# Access Compliance Report

## Public Rights-of-Way

### (Pedestrian Signals)

Intersection ID: N/A	Main Street:	Cross Street: N/A	Location: N/A
ADA ID: 9CFE5C347BFA	Signal Type: One Push Button-Non APS	Overall Compliance: No	Severity Score: BTN 1: N/A BTN 2: N/A No BTN: N/A
Codes/Mitigation Info/Possible Solution		Field Measurements/Component Compliance

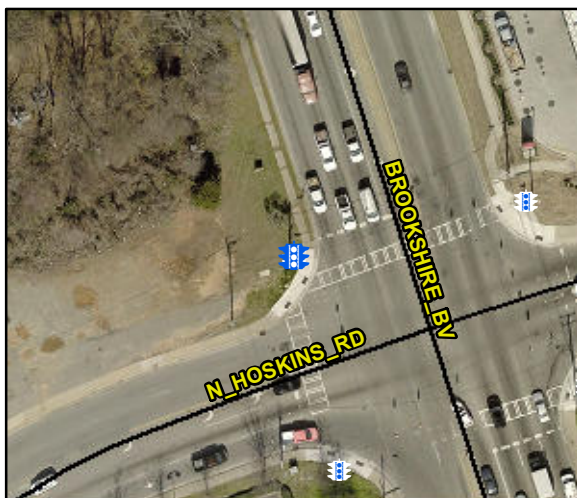
PROW/ADA: R410.6, TMUTCD 4e.08, R404.2, R404.3, R406.2, R404.7.3

Yes	B 1 Clear Xing Direction?	ClearlyMarked	N/A	B 2 Clear Xing Direction?	N/A
	B 1 Crossing Direction	To E		B 2 Crossing Direction	N/A
Yes	B 1 DistanceTo XWalk (in)	0.0	N/A	B 2 DistanceTo XWalk (in)	N/A
No	B 1 DistanceTo Curb (in)	123.0	N/A	B 2 DistanceTo Curb (in)	N/A
Yes	B 1 Diameter (in)	2.0	N/A	B 2 Diameter (in)	N/A

Possible Solutions: Replace Signal Push Button With APS Button on New Post. Remove & Replace Sign.
